Eurofins
Clinical Diagnostics

RE: Mail Control Number 593105

In response to your letter requesting additional information related to our license termination request for NRC License No. 24-35094-01 we have addressed the eight (8) stated deficiencies in narrative form below and have attached requested documents to this letter.

Attachment 1.

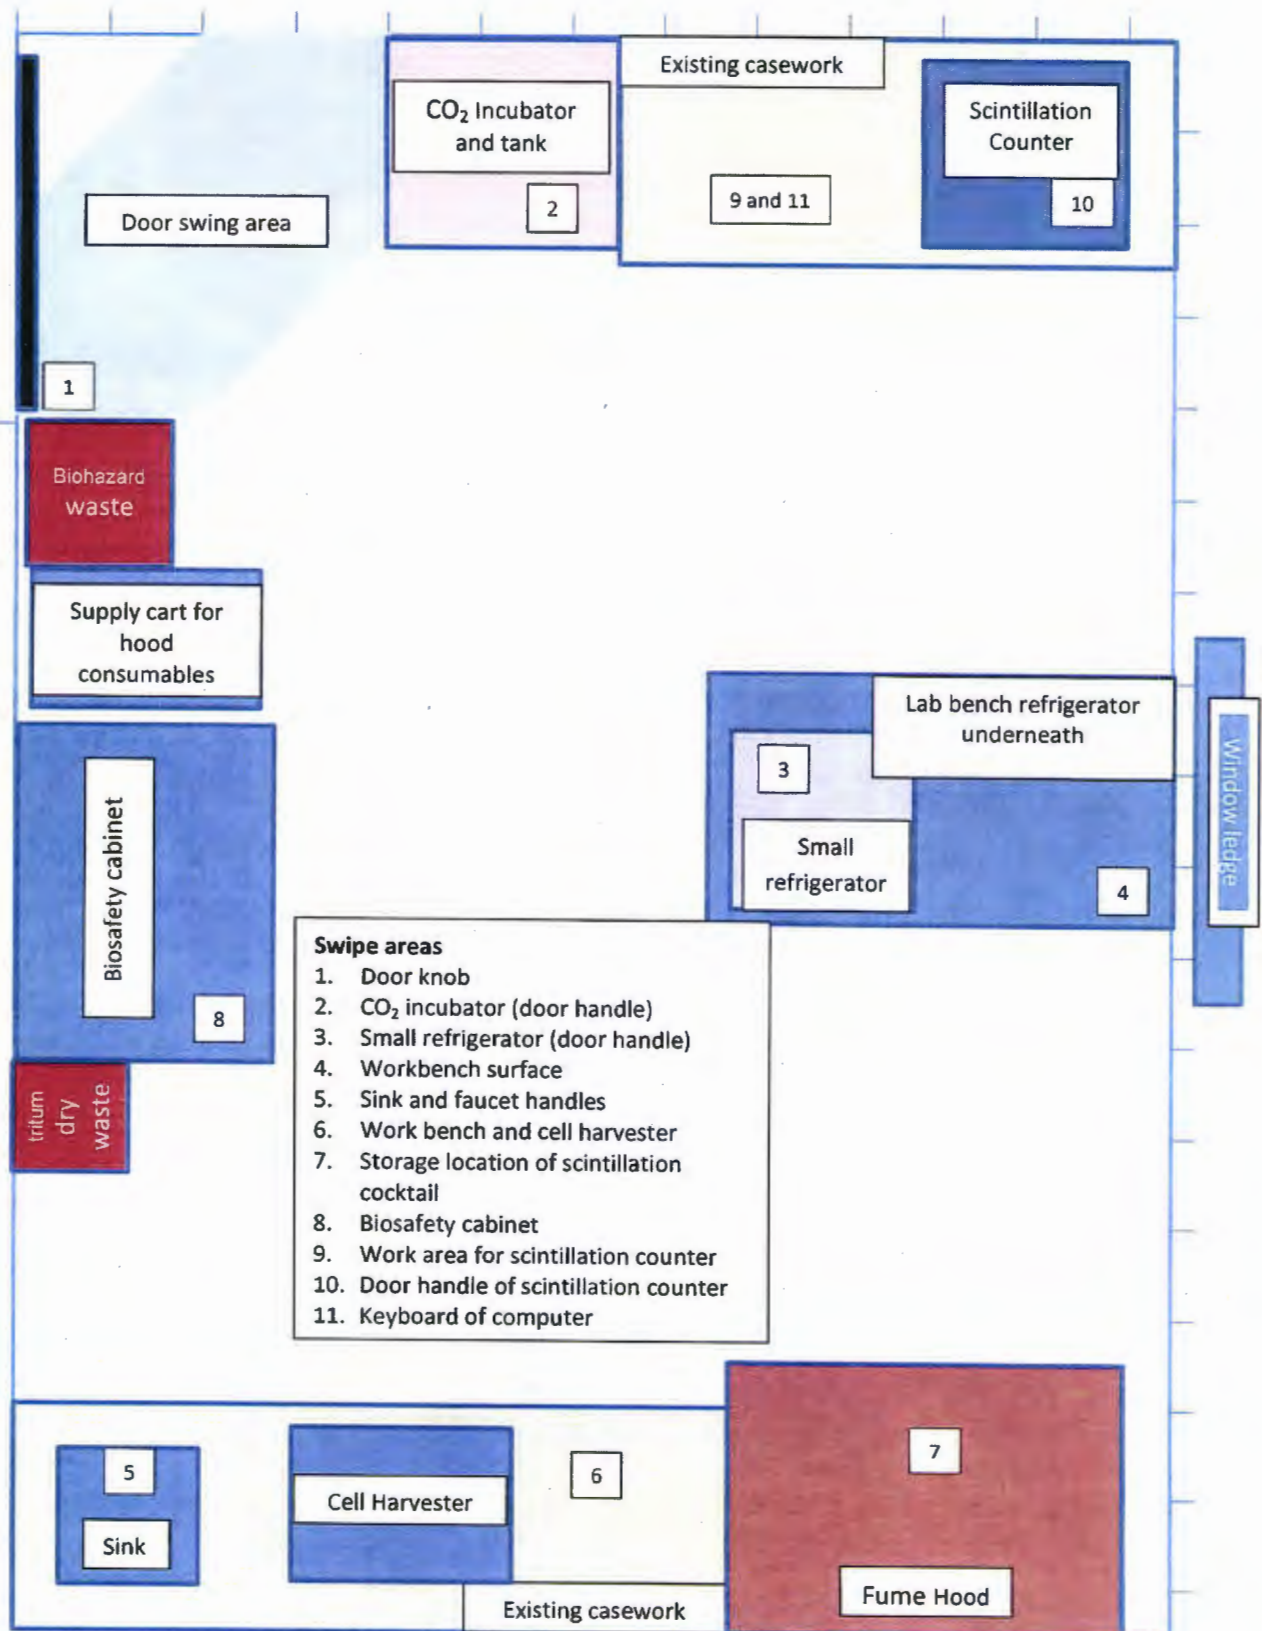
- a) A history of all radionuclides used at your old facility.
- b) A diagram of your old facility with survey and wipe test results keyed to specific locations. Please record your survey results using the appropriate units as described in 10 CFR 30.36 (j) (2) (i), "Report levels of gamma radiation in units of millisieverts (microroentgen) per hour at one meter from surfaces,

and report levels of radioactivity, including alpha and beta, in units of megabecquerels (disintegrations per minute or microcuries) per 100 square centimeters—removable and fixed—for surfaces, megabecquerels (microcuries) per milliliter for water, and becquerels (picocuries) per gram for solids such as soils or concrete”.

- 2) A diagram of the old workspace (**Attachment 1.**) is included with this letter, as are the survey results (**Attachment 2.**). The Scintillation Counter used to analyze the samples does not provide results in disintegrations per time unit; instead results are reported in Counts per Minute (CPM). A search of the instrument literature did not reveal a formula that would convert CPM into disintegrations per time unit format.
